MISSISSIPPI POWER AND LIGHT COMPANY  
PRESERVICE INSPECTION PROGRAM  
GRAND GULF NUCLEAR STATION UNIT 1

ATTACHMENT 1, 2, & 3

REQUEST FOR RELIEF 00002

PROJECT			ITEM	
MP&L GG-1 (JB-1)			HPCS PUMP CASING	
OWN BY	1 D*	SYSTEM	BECHTEL REF DWG	GE REF DWG
CB-26-81	IE22C001C	IE22G001	M-1349A	HP-8-10
R. DILL

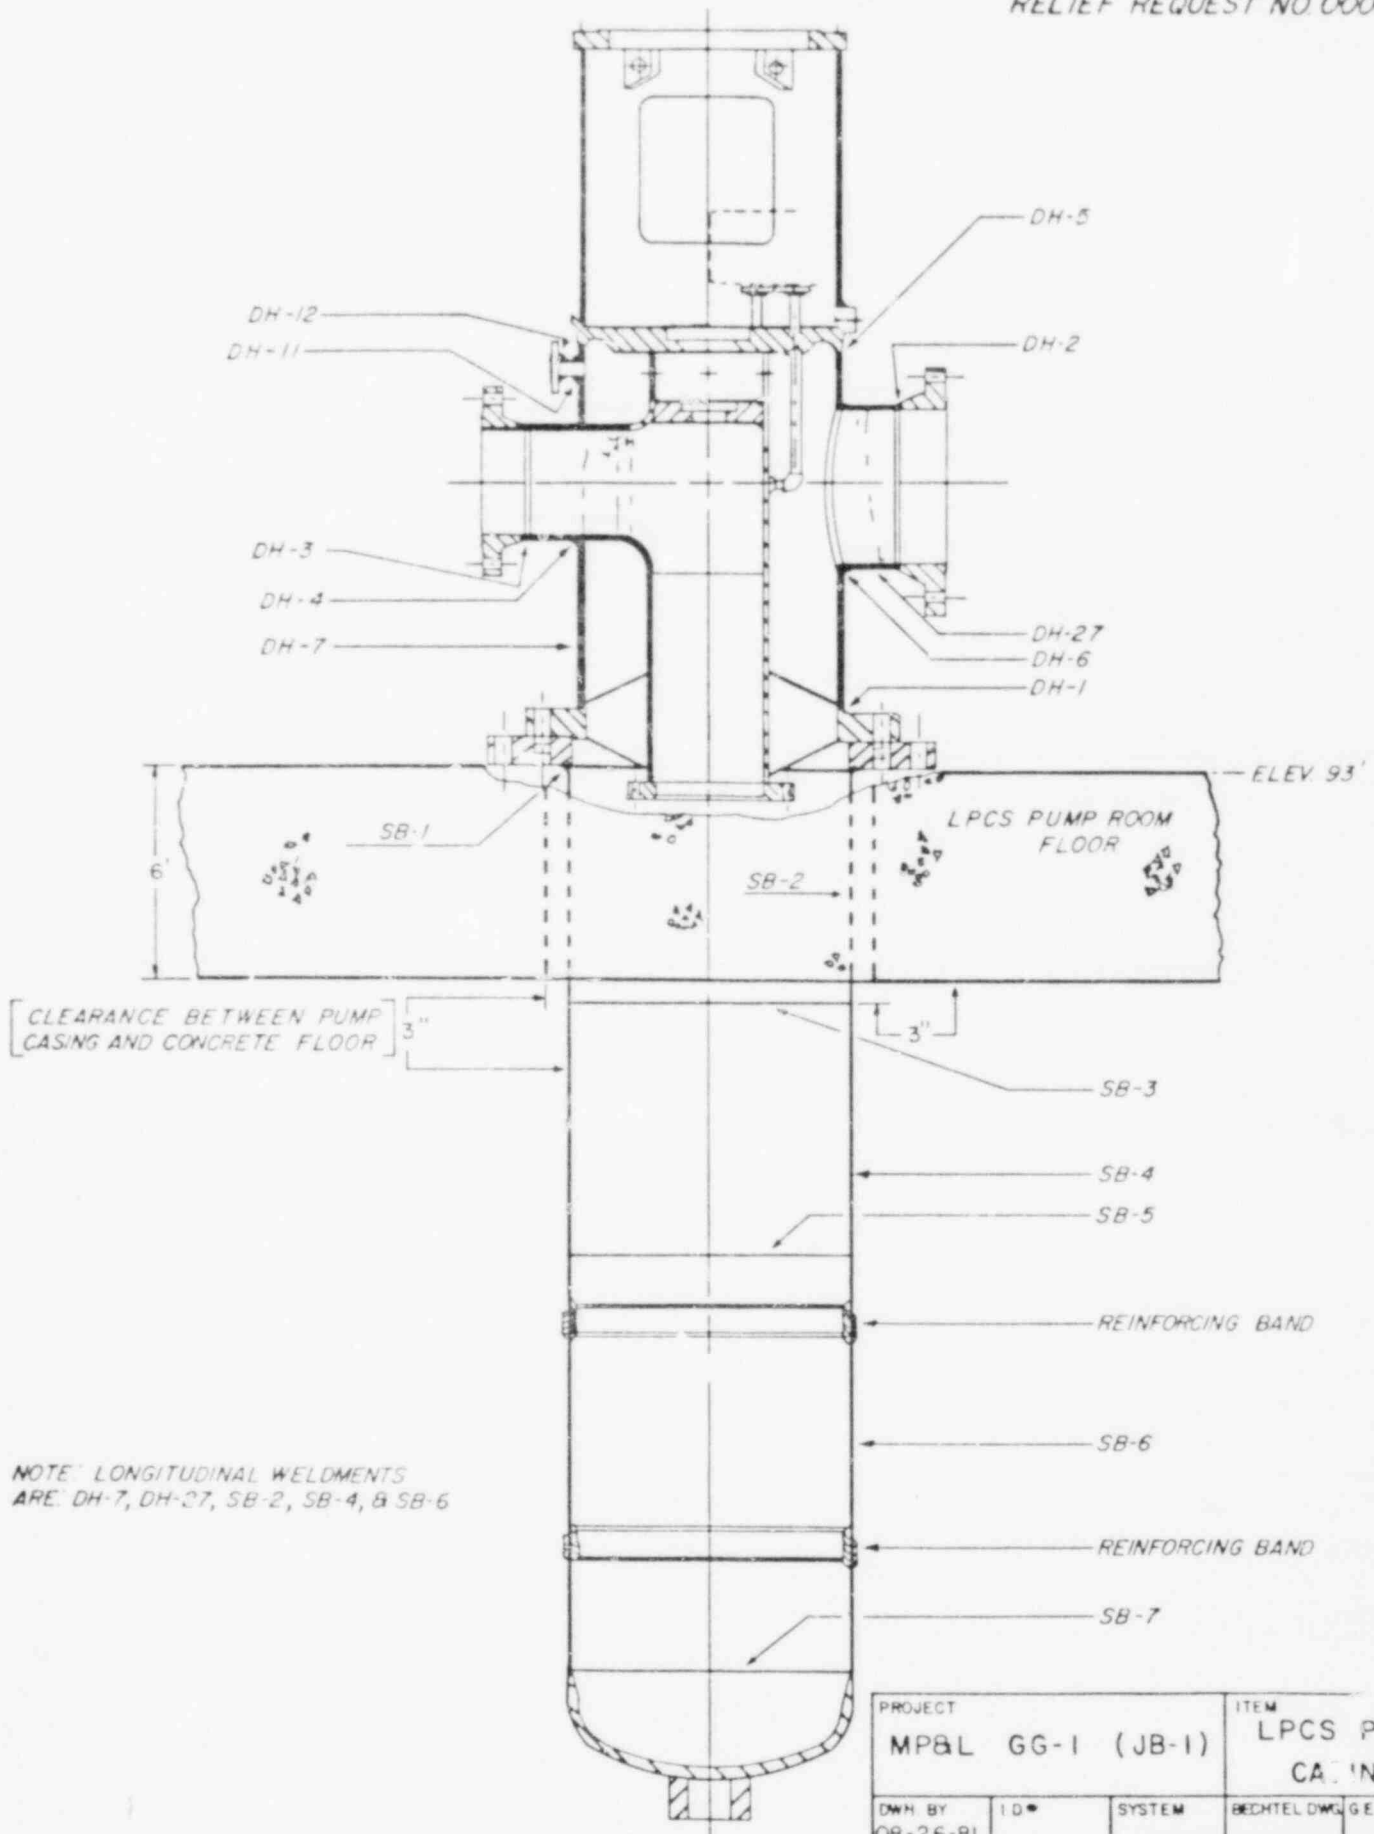
Information to support the determination that the code requirement is impractical: Inaccessible pump casing welds are located where the concrete pump support encasement only allows a 3" clearance between the pump casing and the concrete encasement wall (see attach drawing for details of the design). Due to this limited accessibility, it is impractical to surface examine those portions of welds located within the surroundings of the concrete pump support encasement.

Reasons why relief should be granted: Request for an exemption from Pre/Inservice Inspection of inaccessible portions of pump casing welds on HPCS, LPCS, RHR "B" pumps located inside of concrete pump support encasements. Examination of the accessible pump casing welds will be performed.

PROJECT			ITEM	
MP&L GG-1 (JB-1)			RHR HEAT EXCHANGER	
DWN. BY	I.D.#	SYSTEM	BECHTEL REF. DWG.	GE REF. DWG.
08-27-81 R DILL	1E12B001A	1E12G012	M-1348A	RH-7-19

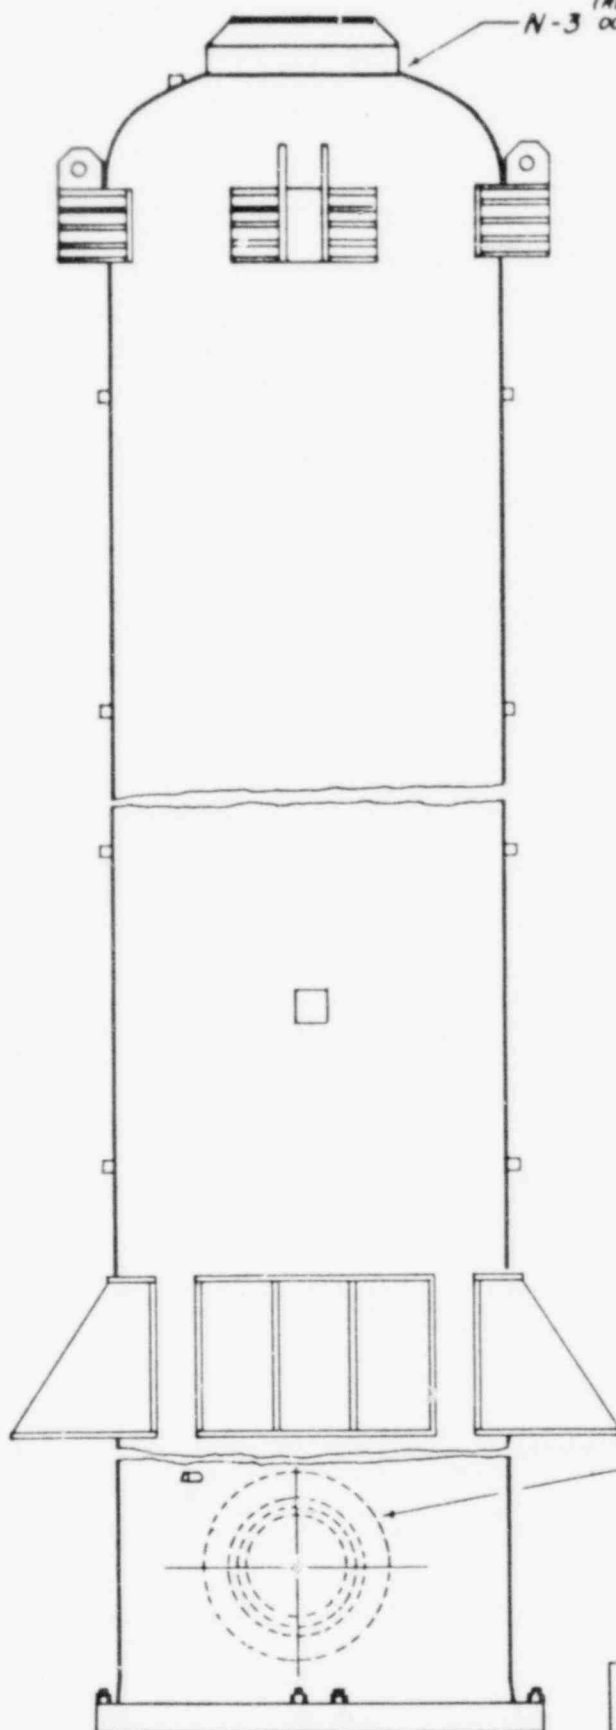
Information to support the determination that the code requirement is impractical for Preservice Inspection: Approximately 1160 man hours would be required to remove and replace, already installed, insulation on the RHR Heat Exchanger Nozzles to perform the Surface Examination. With already acceptable, more stringent radiography and ultrasonics being performed per ASME Section III and General Electric Company specifications on these Nozzles, it is expected that the non-performance of the required Surface Examination will have no adverse effect on plant safety. Therefore, the expenditure of 1160 man hours to remove and replace insulation to perform a Surface Examination is felt to be impractical and will not enhance overall plant safety.

Reasons why relief should be granted: Request for an exemption from Preservice Surface Examinations of RHR Heat Exchanger Nozzle welds N3 & N4. Required Surface Examinations will be performed during the first 10 year Inspection interval.

PROJECT		ITEM	
MPBL GG-1 (JB-1)		THERMAL SLEEVE WELD	
DOIIA (W-54)	DOIIB (W-58)	DOIIA (W-54)	DOIIB (W-58)
OB-25-BI	R DILL	OB-25-BI	R DILL
FROM RMCU		FROM RMCU	
M 1328K		M 1328K	
RH-B-1		RH-B-1	
RH-B-3		RH-B-3

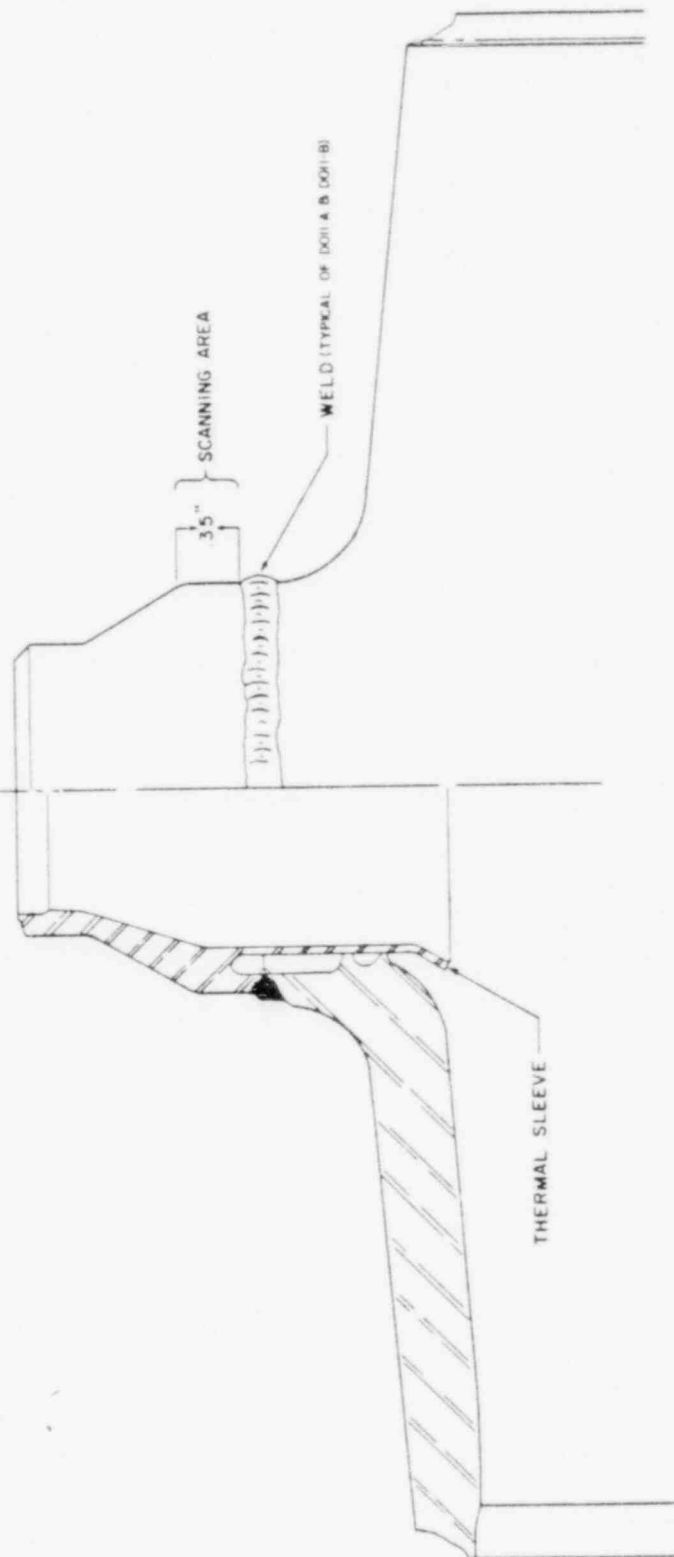
Information to support the determination that the code requirement is impractical: Due to the design of the Thermal Tee Sleeve welds D011A (weld 54) and D011B (weld 58), there is not sufficient area to perform a meaningful Ultrasonic examination. Also, the position of the Thermal Sleeve, as well as lack of internal access, precludes the use of radiography.

Reason why relief should be granted: Request for exemption from Pre/Inservice Volumetric (Ultrasonics and Radiography) inspections of Thermal Tee welds D011A (weld 54) and D011B (weld 58) on the RHR Return to RWCU Line.
